File Number: 5-C-25-IH

**Meeting:** 5/21/2025  
**Applicant:** Jessalyn Friske Remnant Architecture PLLC  
**Owner:** Ashley and Clint Coleman  
**District:** Edgewood Park Infill Housing Overlay District

**Location:** 3124 Clearview St. **Parcel ID:** 70 P A 014  
**Zoning:** RN-2 (Single-Family Residential Neighborhood)  
**Description:**  
Addition.

Level II Addition Visible from the Primary Street

site plan - renovation

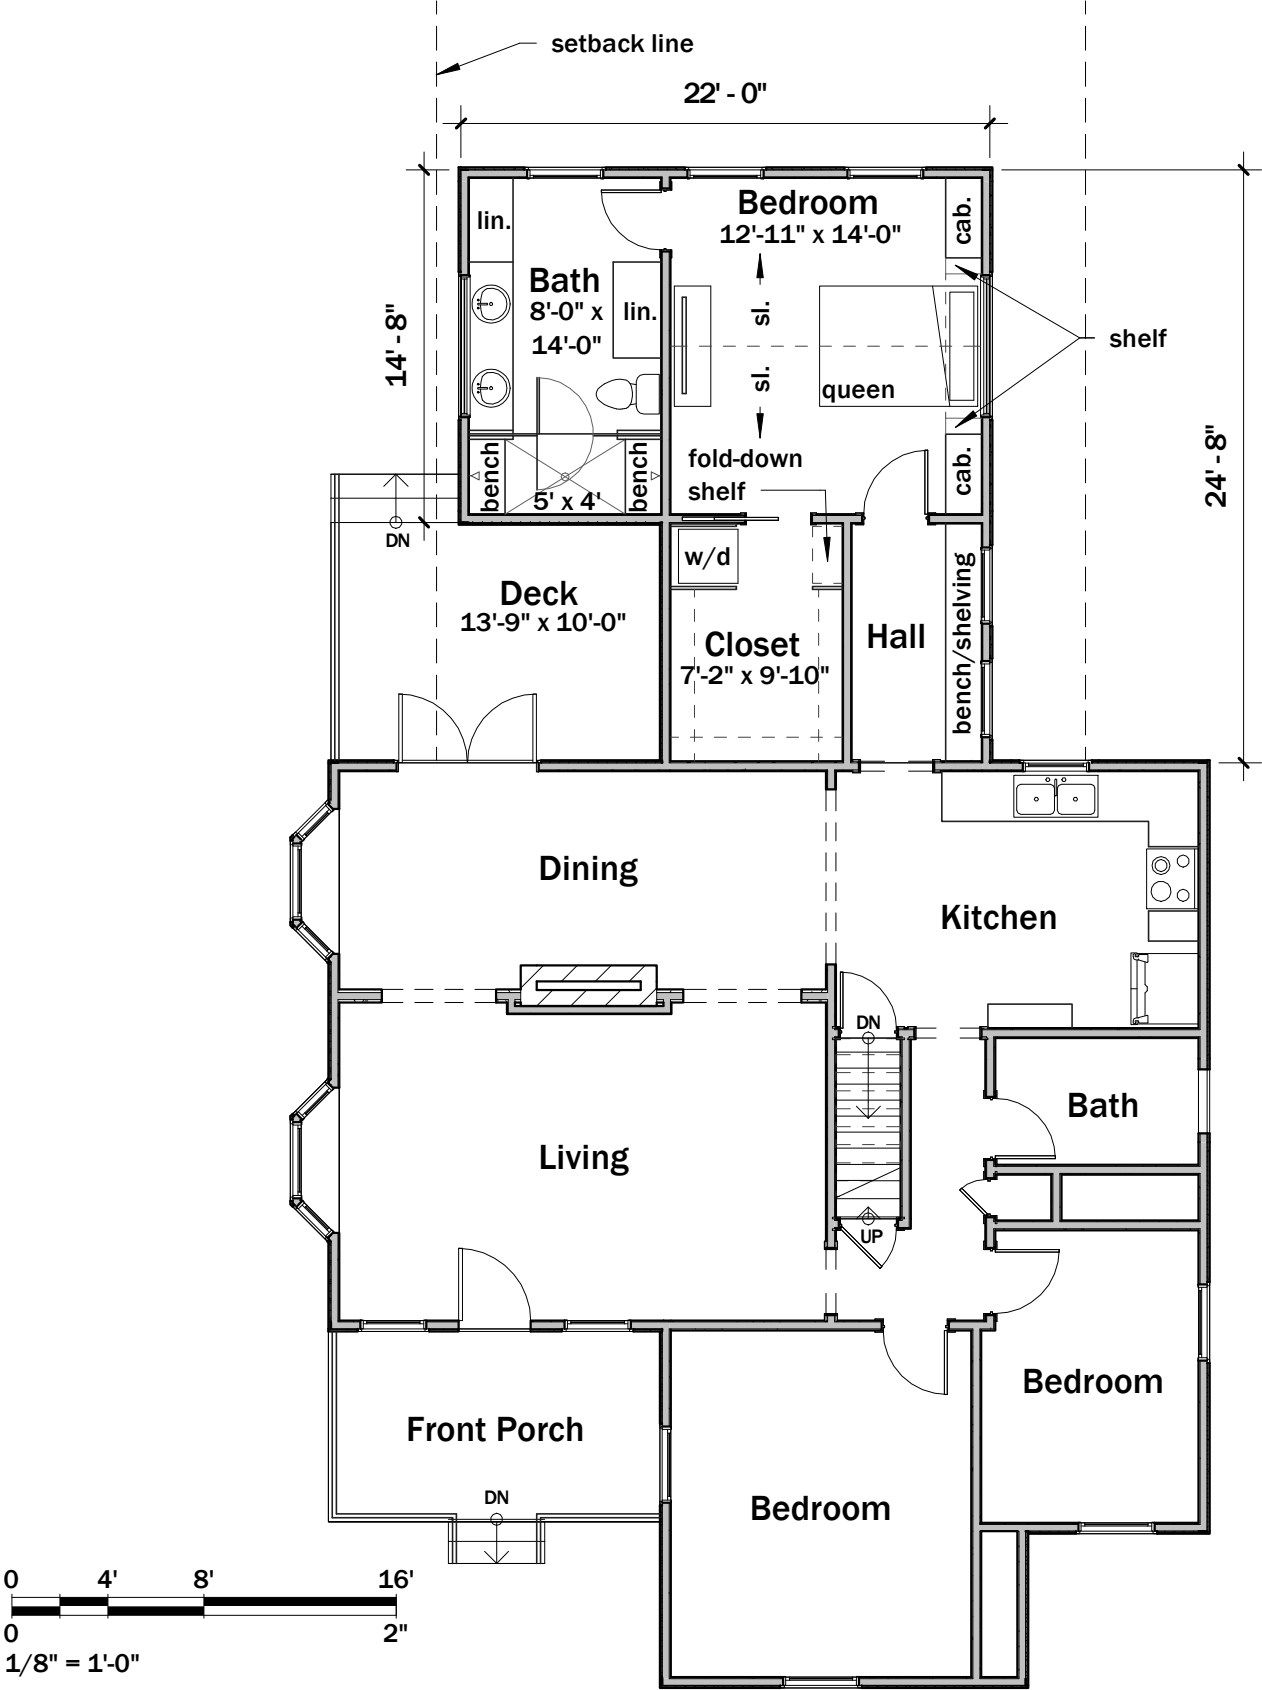
2. The addition is proposed for the rear of the house, which meets design guidelines for placement.
  3. Guidelines recommend that exterior cladding, roof materials, doors, and windows should be compatible with those on the existing house. The proposed in-kind lap siding, asphalt shingles, and 3/1 double-hung windows reflect the existing house and the guidelines. While the transom windows and the stucco-clad foundation are not present on the existing house, they are compatible with the overall design and meet the guidelines.

street side elevation

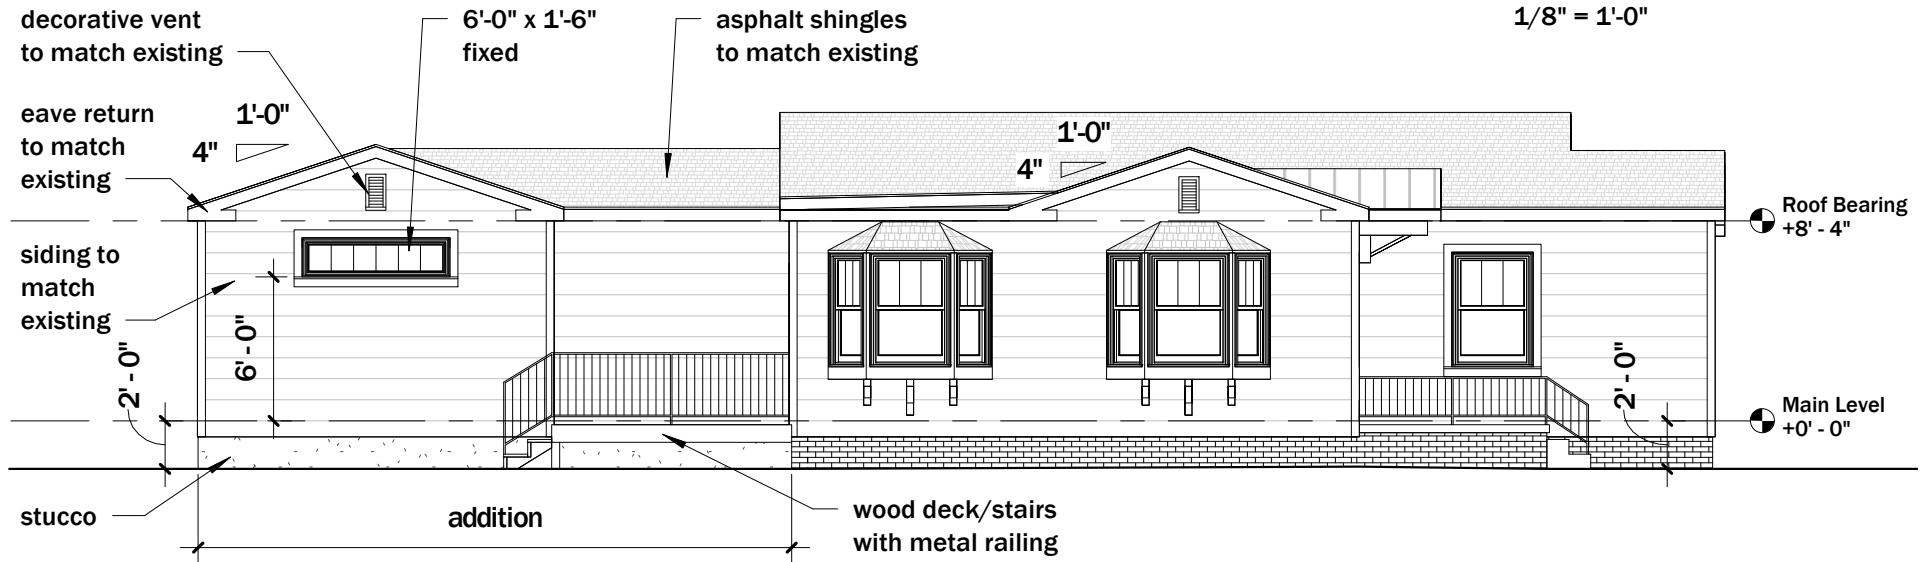
1. Under the Infill Housing overlay, the DRB reviews additions visible from the primary street. The proposed addition will be visible from Clearview Street and from Nickerson Avenue, the side street.

4. Guidelines recommend that the roof line and roofing materials complement the original house. The cross-gable roof form is compatible with the existing house. The addition is recessed below the primary roofline with a lower pitch, which demarcates it as an addition, and it will have the same height as the massing projecting from the façade, with the gable fields matching the height of others on the house
